Subject: Response to DMS Comments for DRAFT Monitoring Year 3 Report
Thomas Creek Restoration Project, Wake County
DMS Project # 96074, DEQ Contract #5549, RFP# 16-005020

FINAL

Thomas Creek Restoration Project

Year 3 Monitoring Report

Note: Per DMS/IRT request, bank height ratio for MY3 has been calculated using the as-built bankfull area. All other values were calculated using the as-built bankfull elevation, as was done for previous monitoring reports.

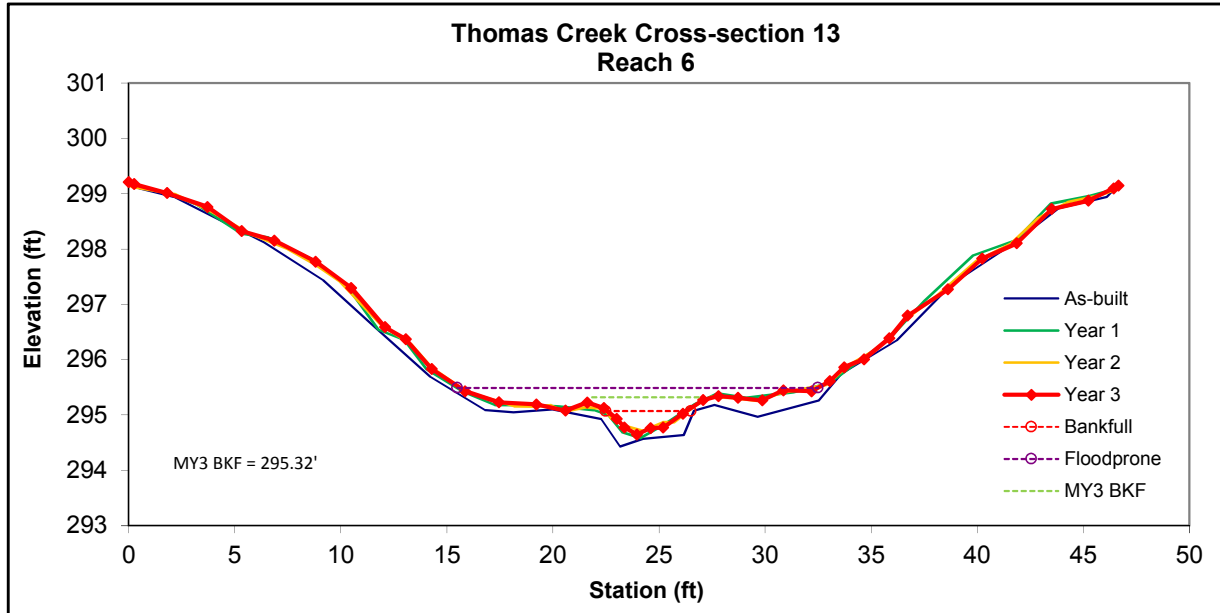
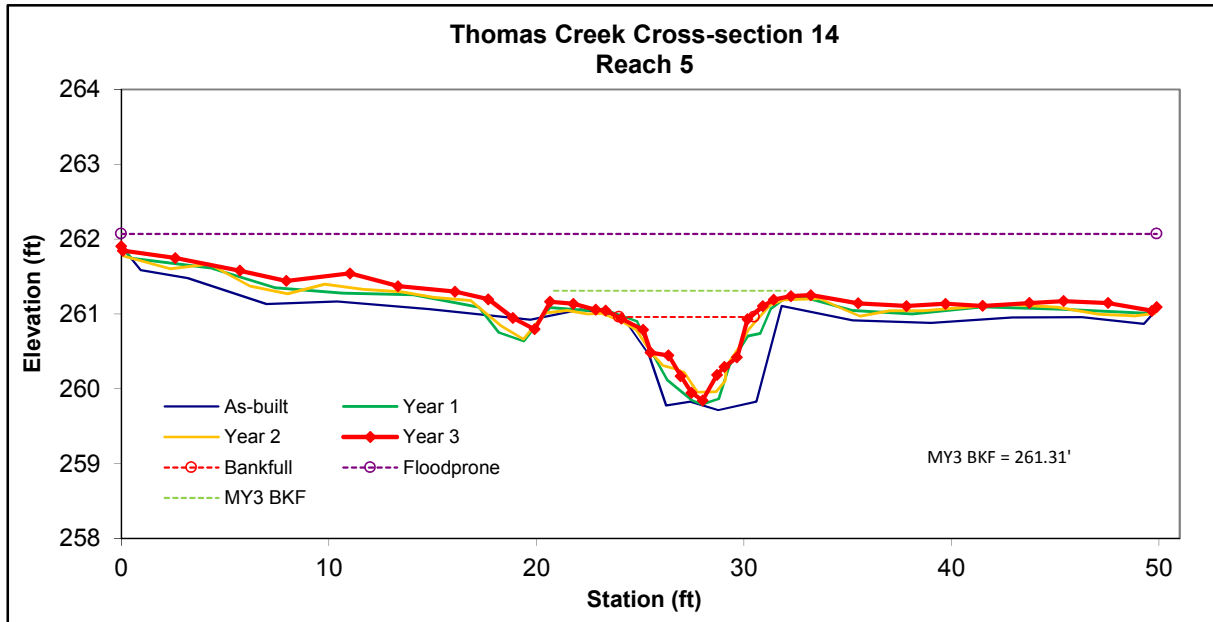
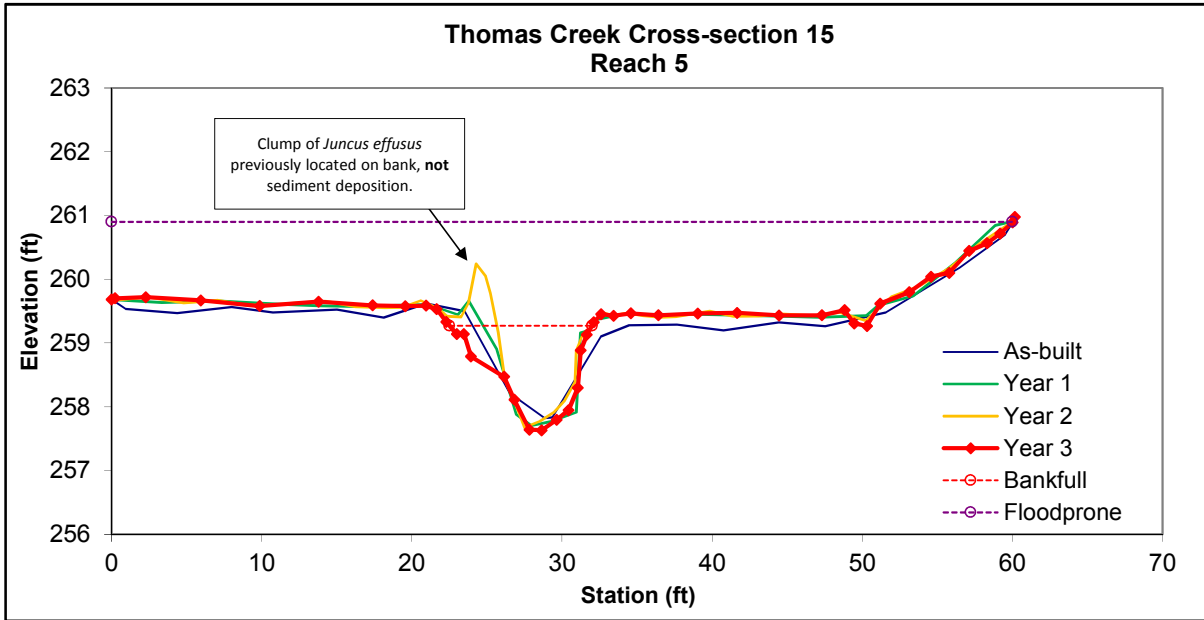
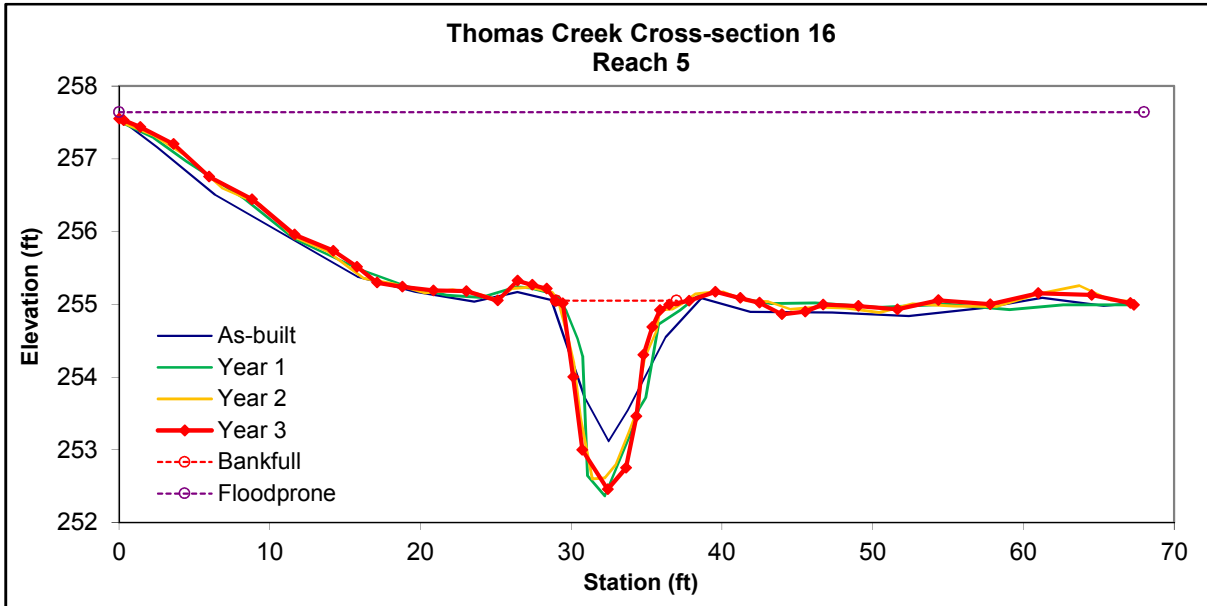
4. Appendix D, Table 11: During our review of the Bank Height Ratios (BHR) in Table 11, DMS staff performs a visual comparison of the MY3 data to As-Built/Baseline cross-sections. DMS noted/realized that by displaying the As-built Bankfull Cross-Sectional Area alone, the calculation for the BHR can be difficult to reconcile. We noted possible discrepancies in the BHR calculations for cross-sections 1, 3, 4, 5, 6, 7, 10, 12, 13 and 14 given this disconnect. Using the new BHR calculation methodology where the As-Built Bankfull Area is held constant, please display the Year 3 bankfull elevation as another data series just for the sake of clarity between the BHR calculation and the overlay. It appears that the BHR calculations were done correctly, but just please add the MY3 bankfull data series with its elevation for the sake of clarity to the reader.

Response: An additional data series was added to each cross-section figure showing the MY3 bankfull line (generated using the as-built bankfull area as per the recent DMS memo) as requested. The BHR calculations for the listed cross-sections were re-checked again and were all confirmed as correct. With the new bankfull line shown, a visual comparison between it and the MY3 cross-section data certainly makes the BHR value appear to make intuitive sense.
